**ROCKY MOUNTAIN
ENERGY COMPANY**

RE: License SUA-1338
Docket No. 40-8697

Pursuant to Condition No. 14 of the referenced Source Material License, Rocky Mountain Energy (RME) is providing written notification that restoration of Pattern 2 at our Reno Creek ISL test facility has commenced.

CARBONATE RESTORATION CIRCUIT (REVISED)

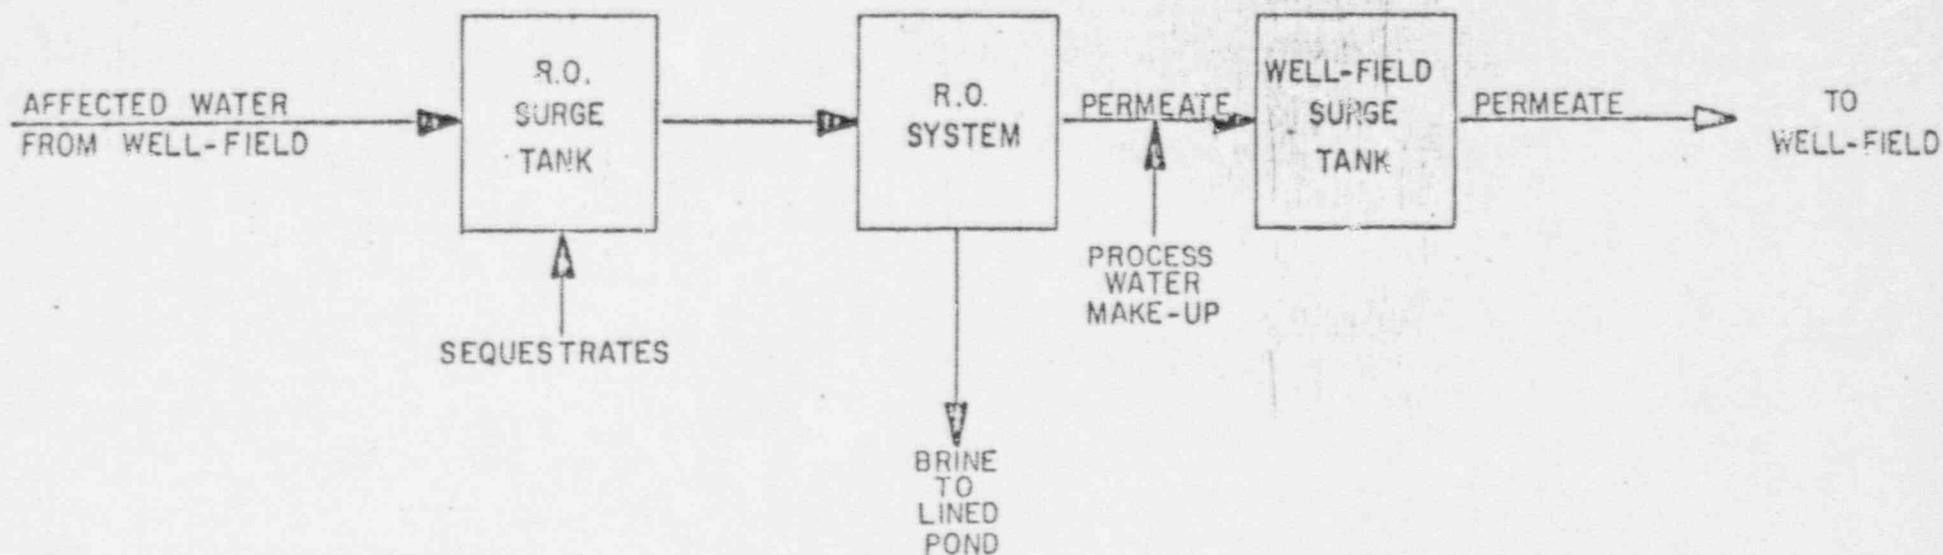
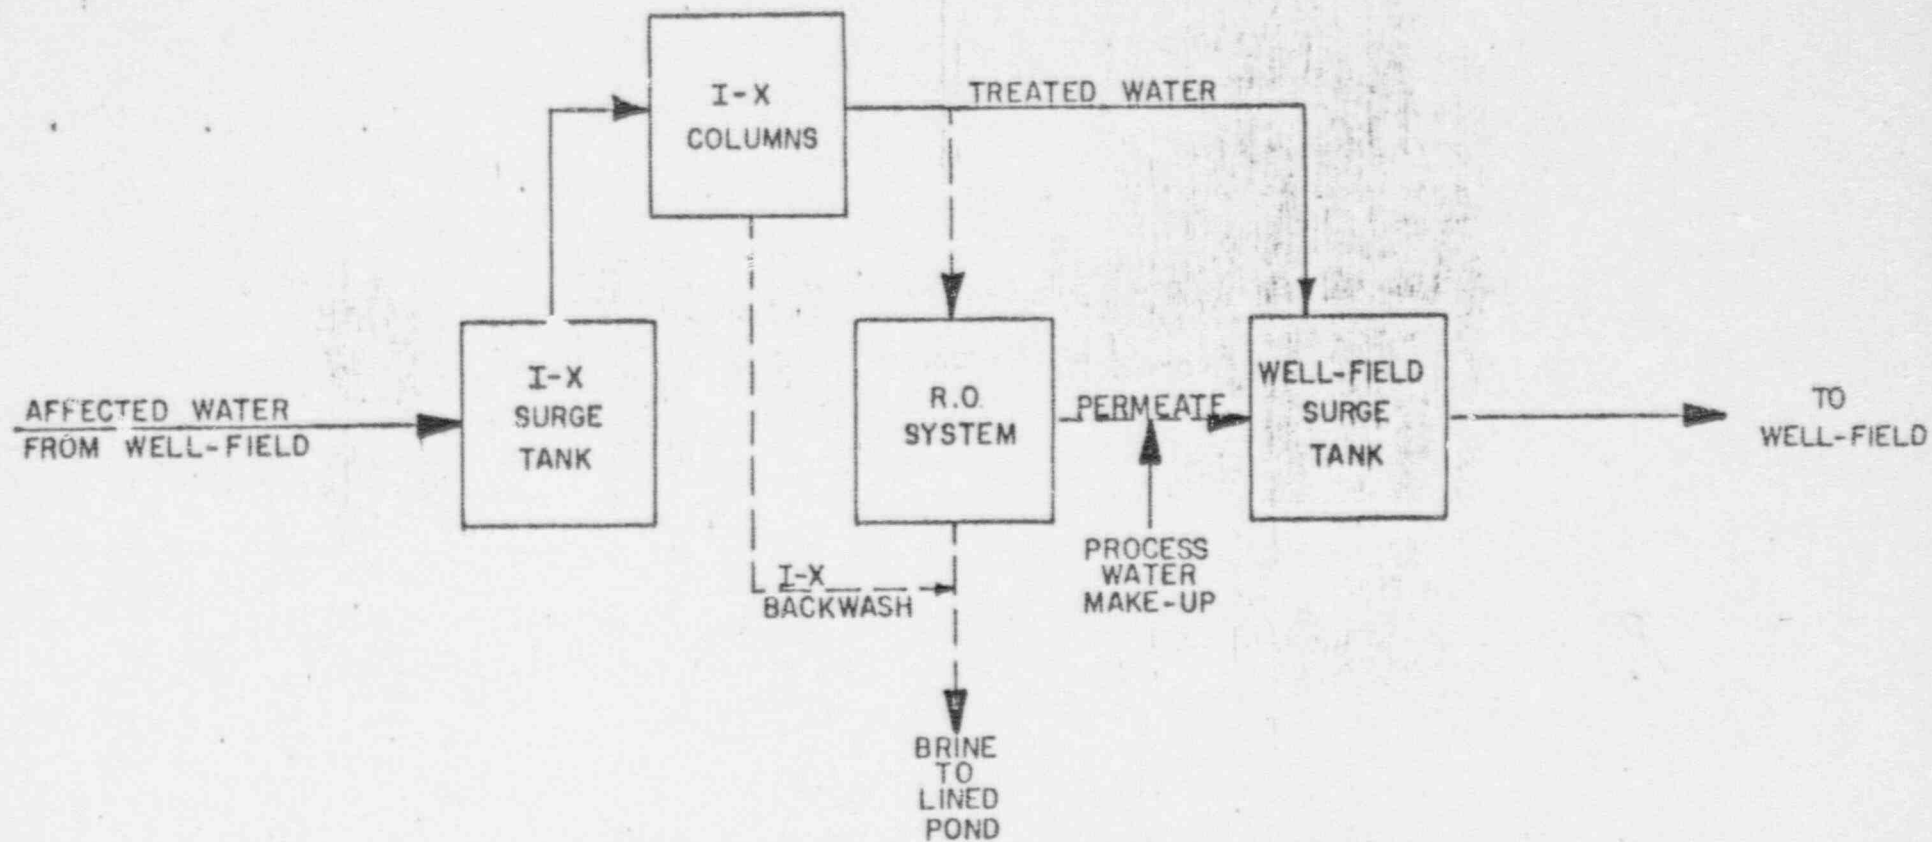
During the initial phase of restoration, it was suggested that pre-treatment of the production fluid by an ion exchange process prior to R.O. would greatly speed restoration. Accordingly, I.X. columns were prepared to strip divalent cations from the production fluid by means of a weak acid resin. Evaluation of the effectiveness of this treatment method indicated that the ion exchange process was performing well enough to eliminate the need for treatment by P.O. Revised Drawing No. RC-P-05-005 shows the general restoration process used.
